Memo

Application: Z10-0099

645 Fraser Road

Rezoning Application

Figure 1.1 - Existing Water Service

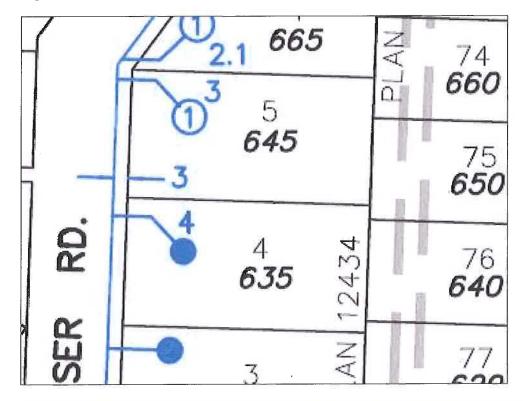
The existing water supply to the subject property is shown on Figure 1.1 below. A 100mm diameter AC main is located in front of the lot at a location 3.0 metres west of property line. The existing service to the property is located at the northwest corner of the lot.

For construction of a second dwelling on a property, each residence must have a separate water service. In this case, a new service connection is required from the water main to the building. From the water main to the curb stop at property line, the line would be owned and maintained by BMID. BMID staff will install the new water service and curb stop to the property line, billed to the owner.

Beyond the property line, a new private water service pipe must be installed to the building. The owner is responsible to install this line, maintain it and eventually renew it. The cost for the service installation work carried out by BMID would approximately be \$1,500 to \$2,000. The BMID work is to be completed via a BMID issued work order, and the cost of materials and labour are billable to the property owner upon completion of the work.
